LOWER MINNESOTA RIVER WATERSHED DISTRICT

Lower Minnesota River Watershed District Board of Managers Meeting

Item 6. H. - Project Reviews

Technical Memorandum

Figure 1: Minnesota Bluffs Regional LRT Trail (Barr)

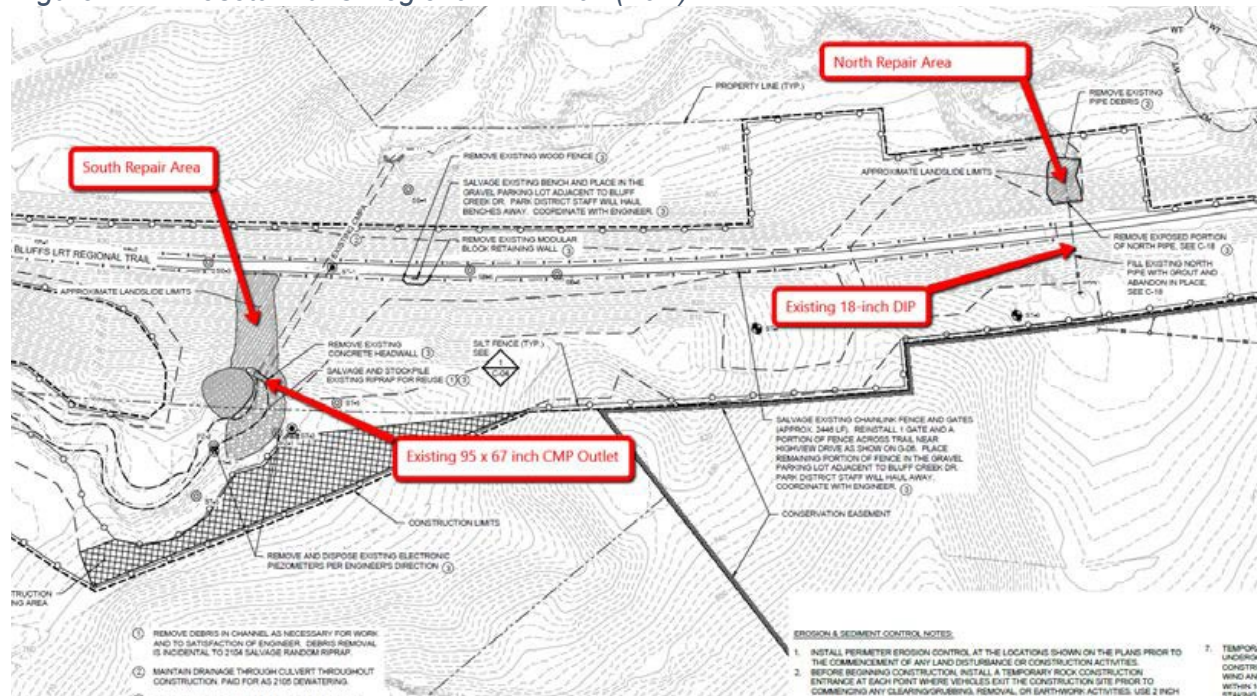
- *Drainage Calculations:* On January 21, 2020, Barr provided the Project's Hydraulic Design Summary Memorandum (Memo). The Memo provides the reasons for the changes to the existing conditions hydrology and hydraulics, as well as a summary of the design basis for the hydraulic structures implemented

(see Figure 1). Specifically, to fortify the existing drainage channel in the south repair area, the stream channel was armored with riprap, boulder cross-vanes, and a stilling basin to help mitigate future erosion. The modifications in the south repair area do not include the creation of new discharge points along the steep slopes. However, the proposed stream channel design represents a change to the existing hydrology. In the north repair area, the existing 18-inch culvert was abandoned and replaced with a channel and a new 24-inch culvert. Barr's analysis shows that water stored upstream of the proposed culvert will not cause flooding problems because enough storage is provided. Barr has provided satisfactory justification for the modifications to the hydrology, as they represent efforts to stabilize the slopes and accompanying drainage channels.
